Report By:

Report: TAB Report
Function: Test, Adjust, & Balance
Date: 02/02/2026
Completed By: National TAB

PROJECT
02-02-26 WAWA #8241 ALLENTOWN, PA

Project: 02-02-26 WAWA #8241 ALLENTOWN, PA

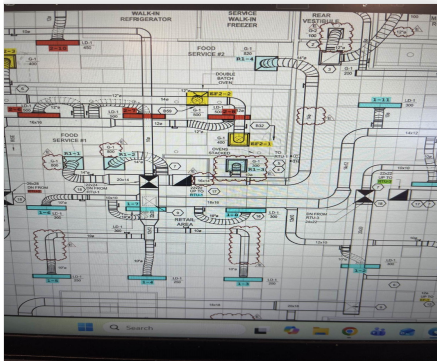
Issue Name : GAS To Building/RTUs
Description : Gas is not yet connected to the building, heating is not functional on the RTUs, once gas is connected ensure proper RTU heater startups and testing is completed.
Created By : National TAB **Assigned To :** National TAB - Will Turnbough
Status : Open
Priority : InfoOnly **Asset Tag :**
Originated Date : 02/03/2026 - Tyler Youells - National TAB

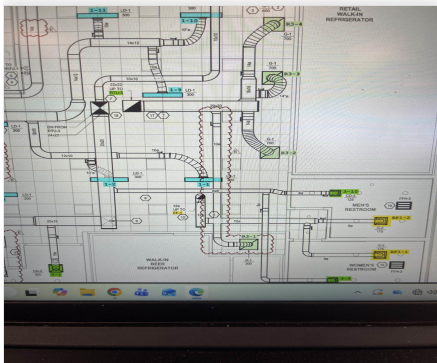
Issue Name : Return Grille R1-3
Description : Return Grille 1-3 is not installed per the revision E. NTab balanced per pre revision plans. Review and rectify if return is to be installed or excepted as-is. Return is intended to be located above the express case.
Created By : National TAB **Assigned To :** National TAB - Will Turnbough
Status : Open
Priority : Medium **Asset Tag :**
Originated Date : 02/02/2026 - Tyler Youells - National TAB

Asset: EF-1

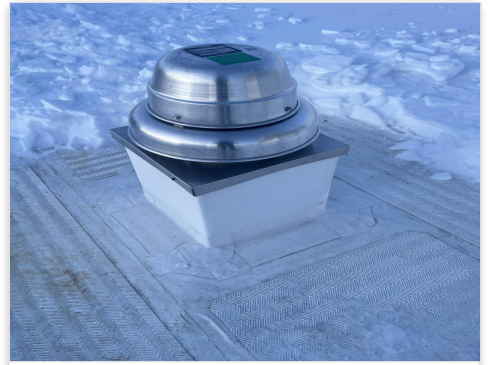
Ef-1 did not have a speed controller, but it was not needed, the fan needs to be full speed
